ADDENDUM #2

Rye City School District

Osborn Elementary School

Midland Elementary School

4 DETAIL - SLIDING DOOR HEAD
SCALE: 3" = 1'-0"

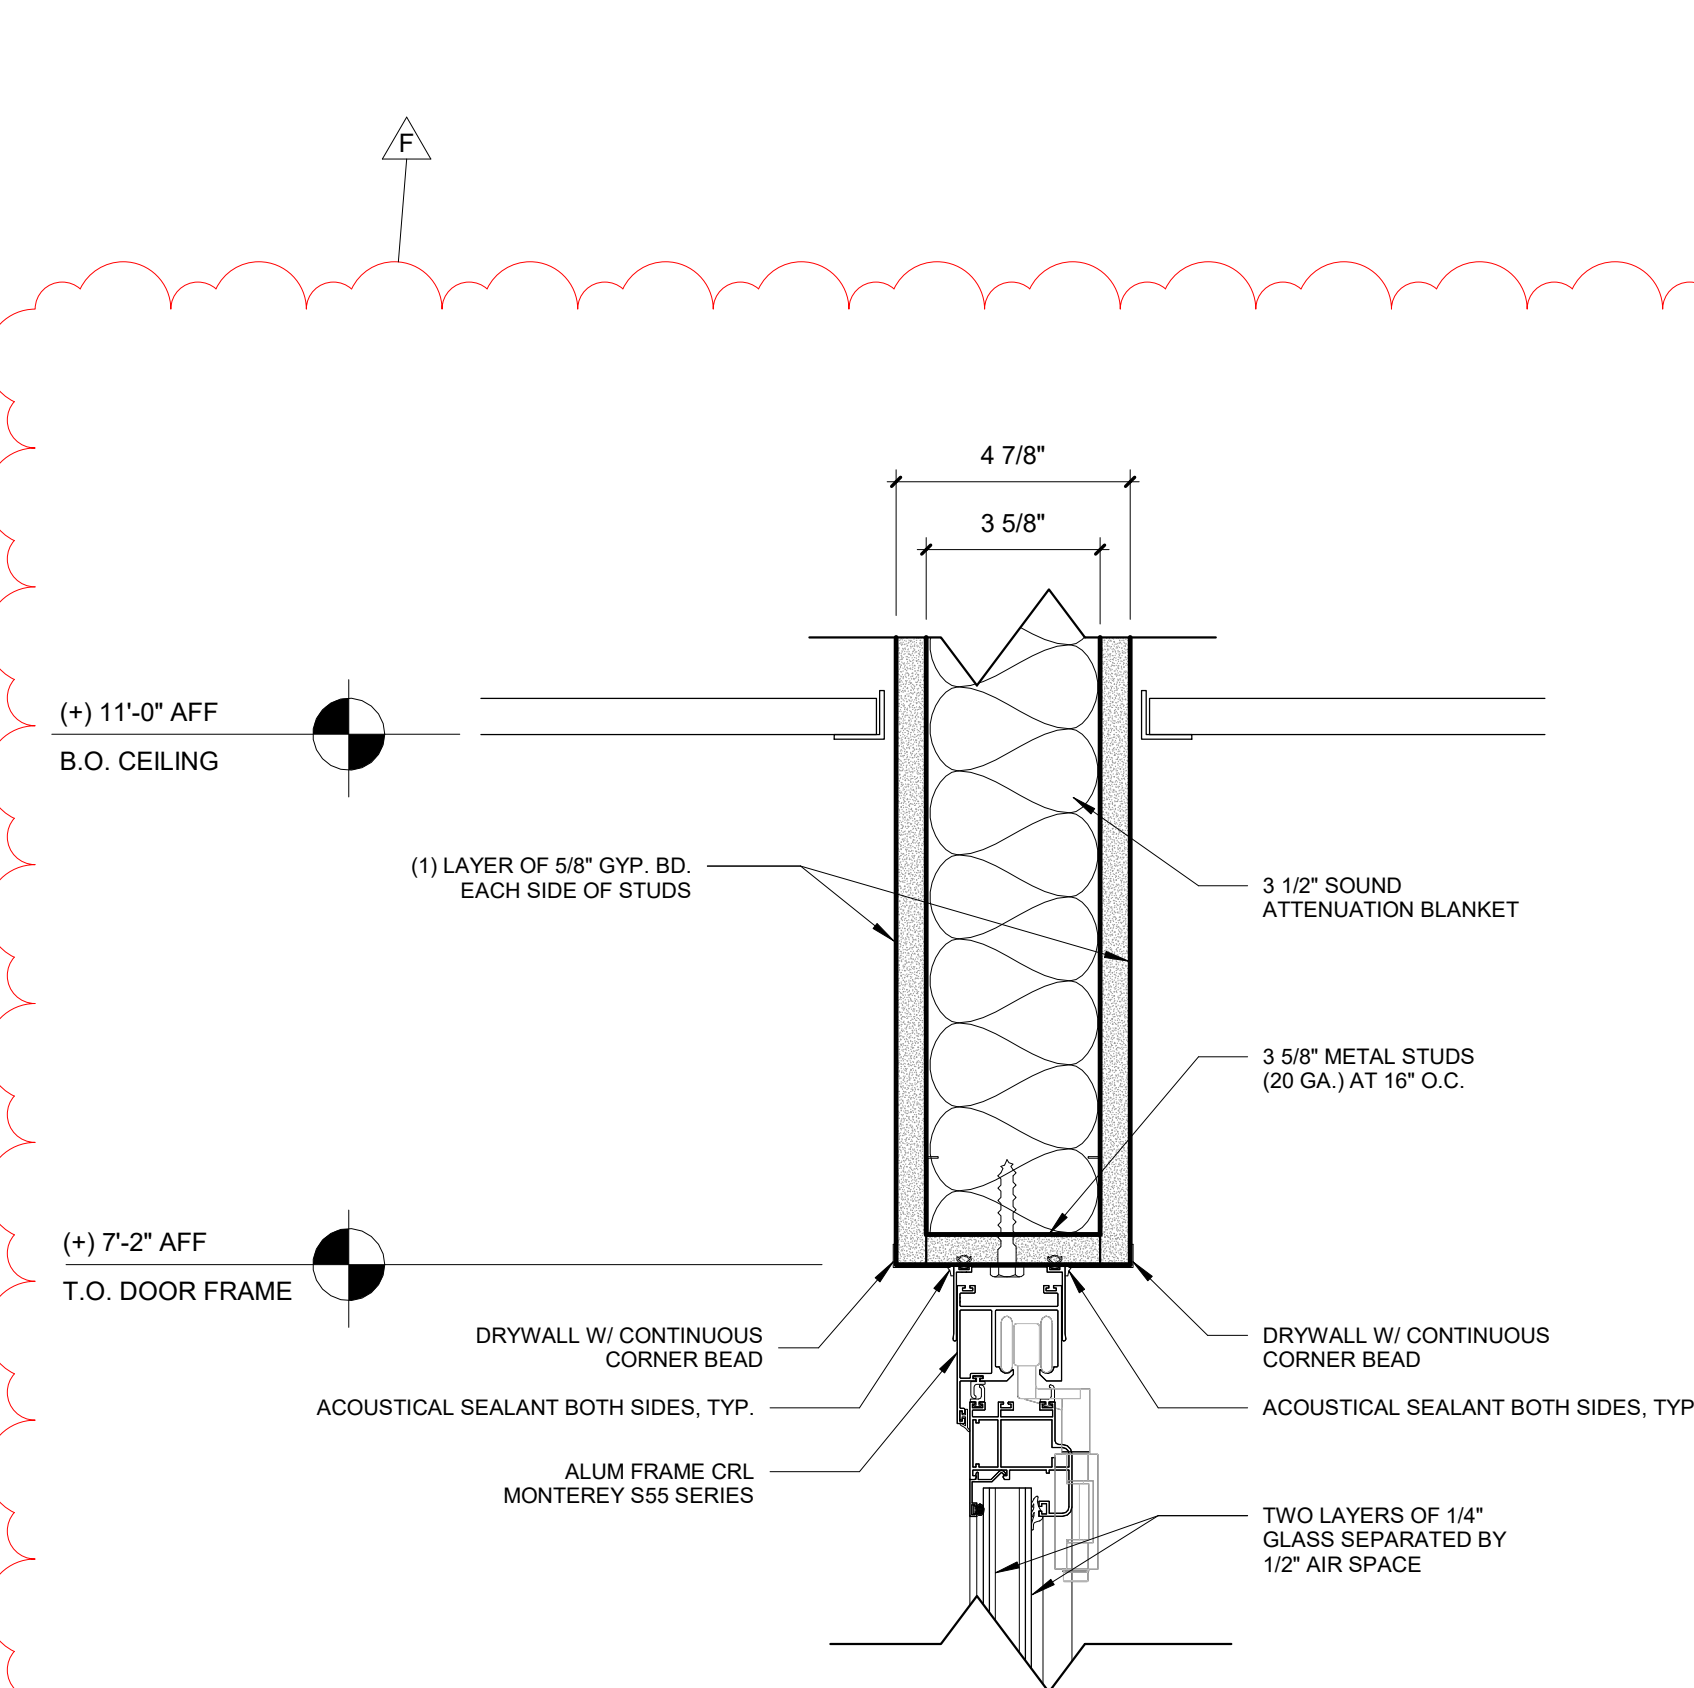
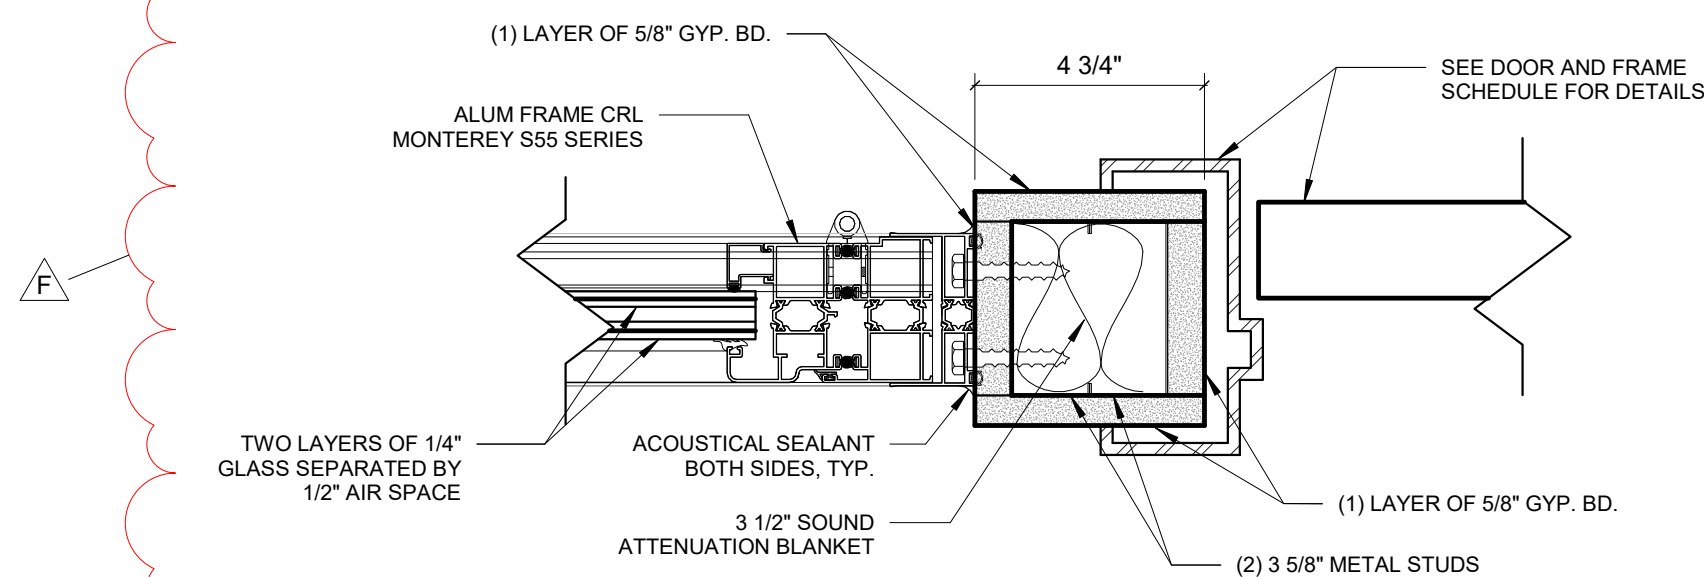
- a. Door head and jamb details added

SEAL & SIGNATURE DATE: 08/16/21
PROJECT No: 9200
DRAWING BY: Author
CHK BY: Checker
DWG No: A3-205

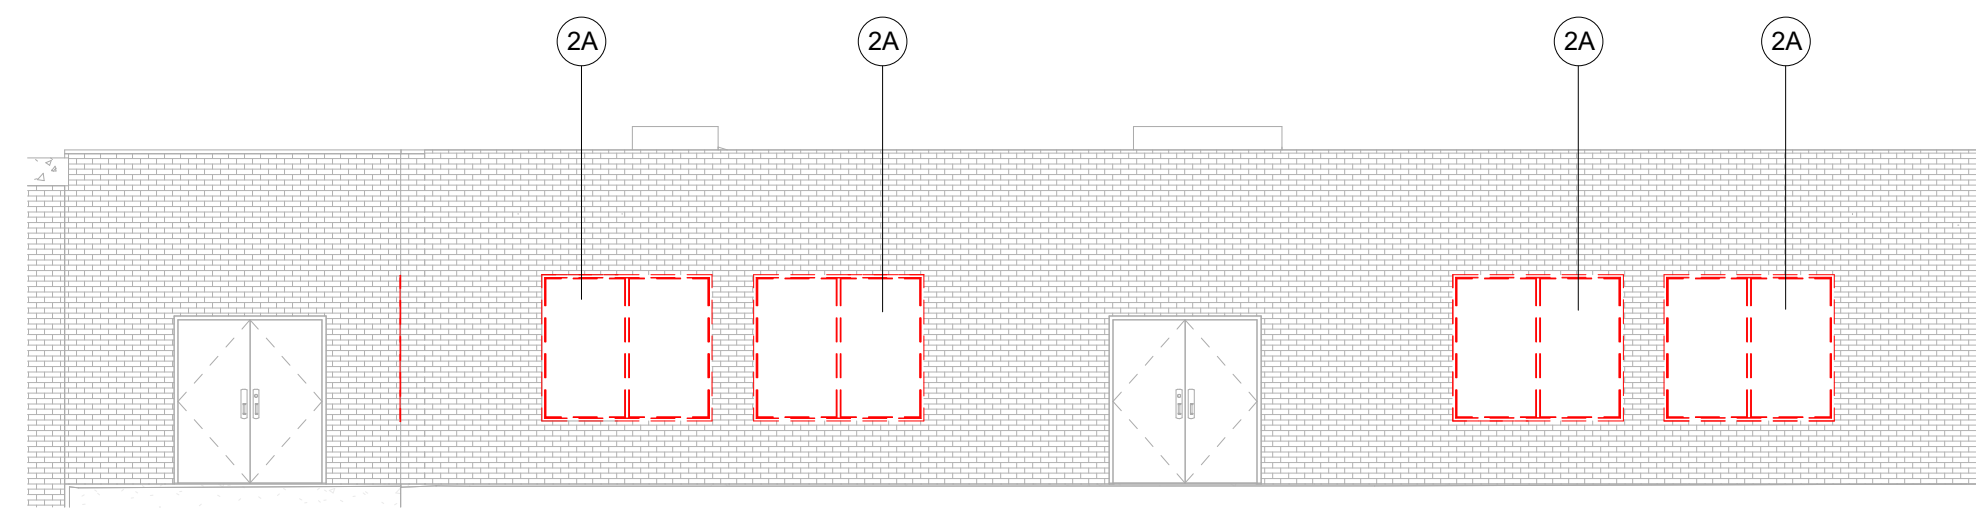
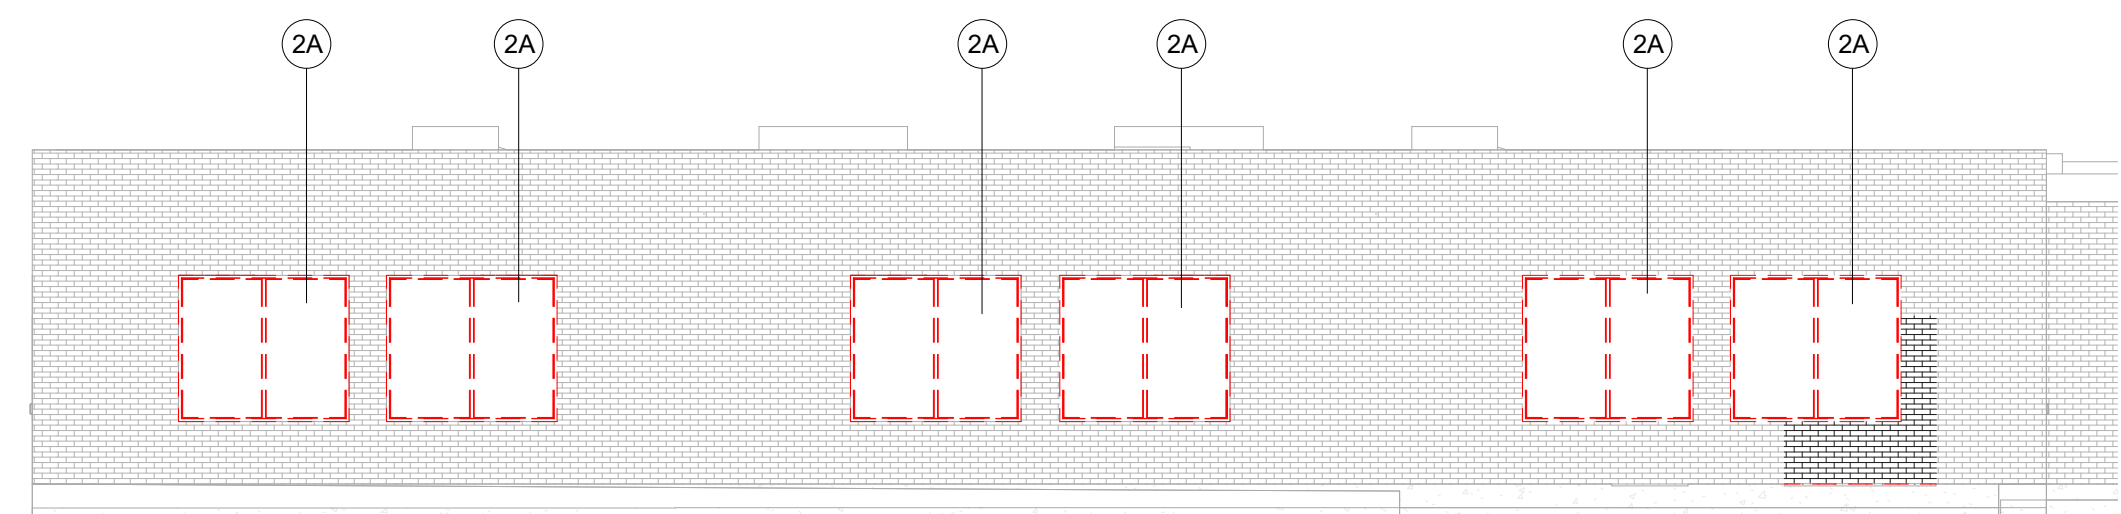
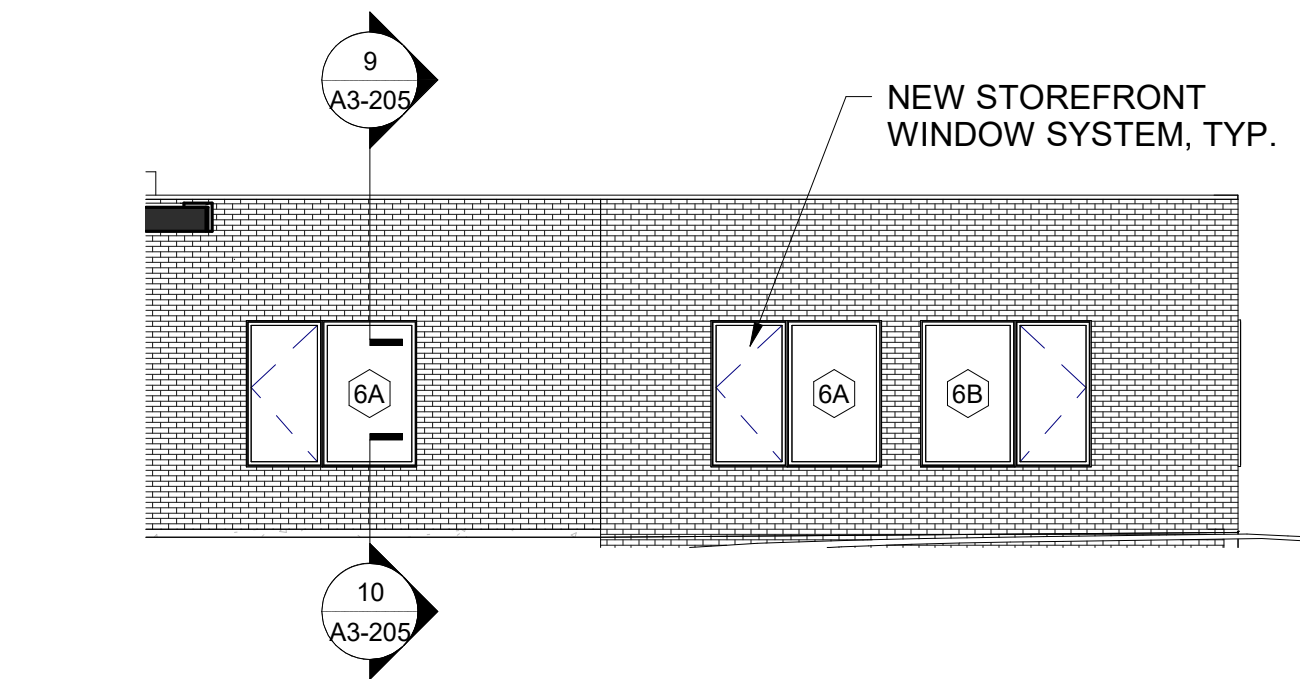
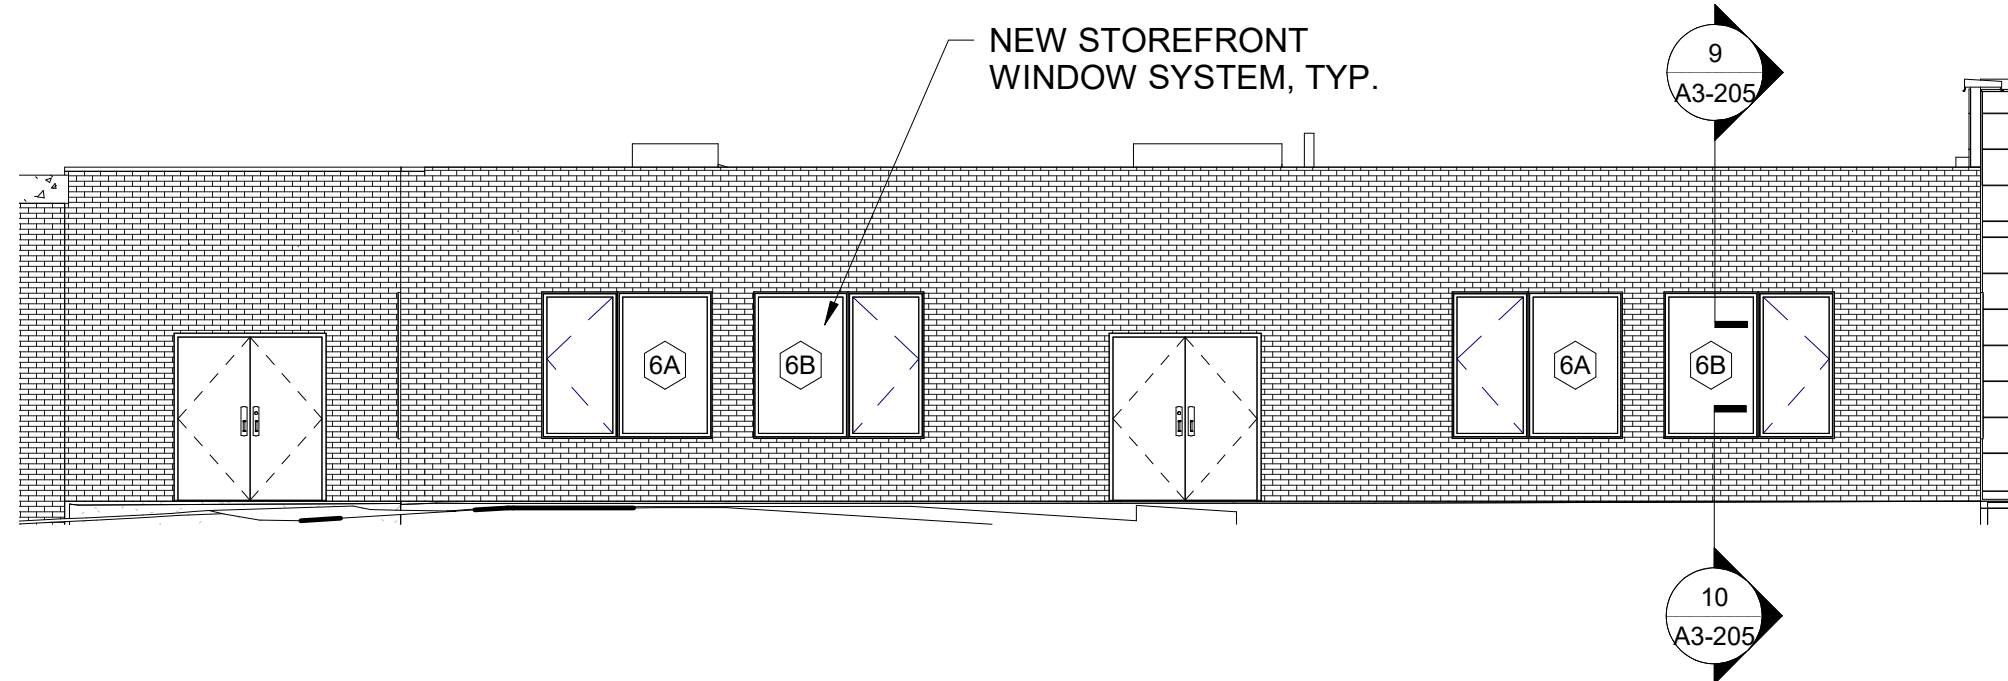
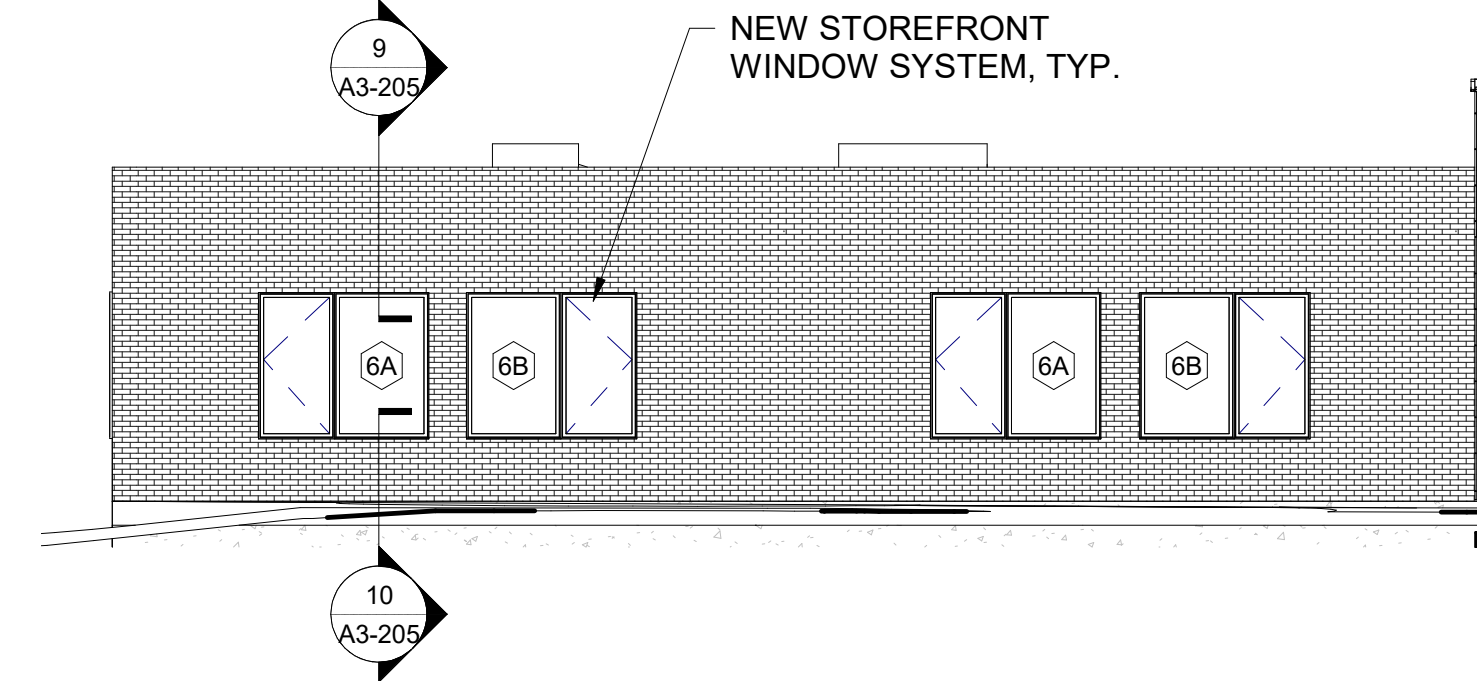
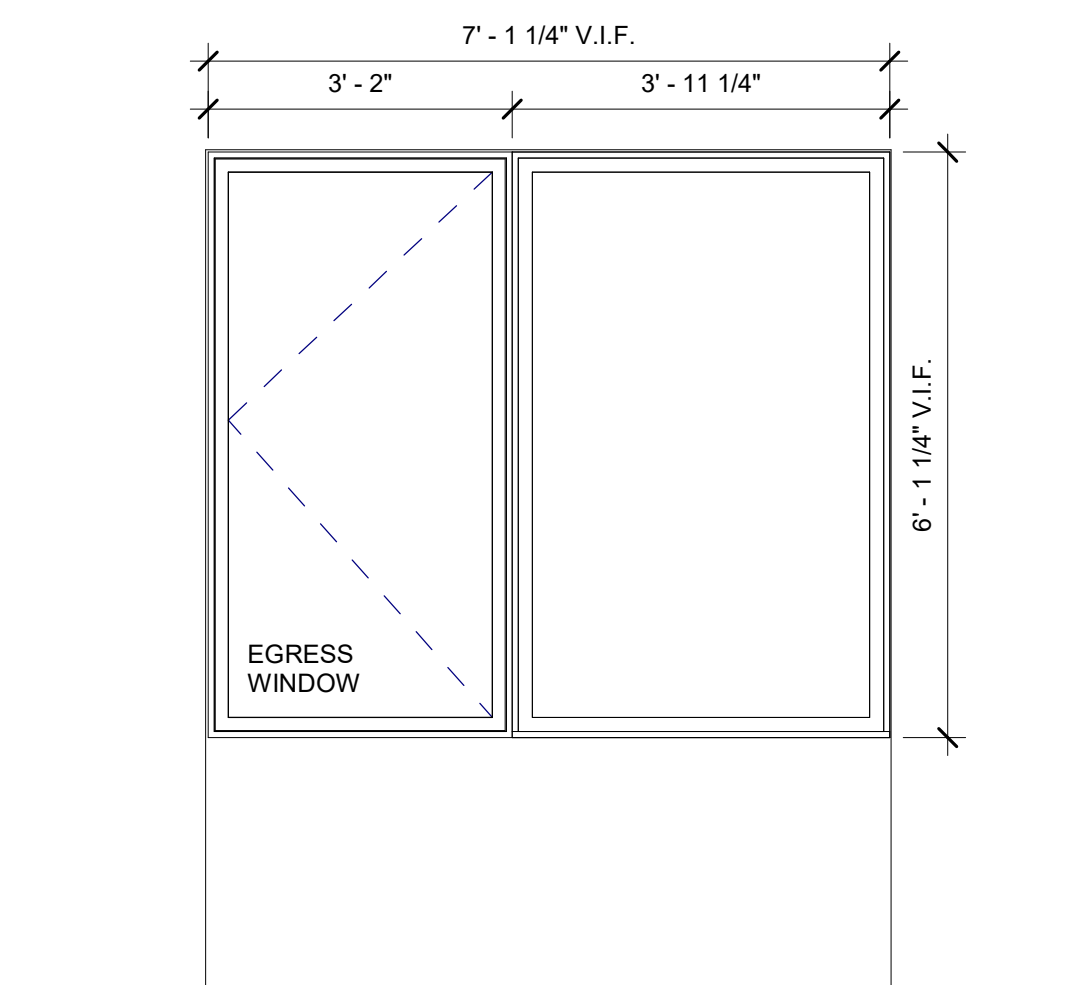
- a. Sheet added to show elevations and details for window replacements at existing building.
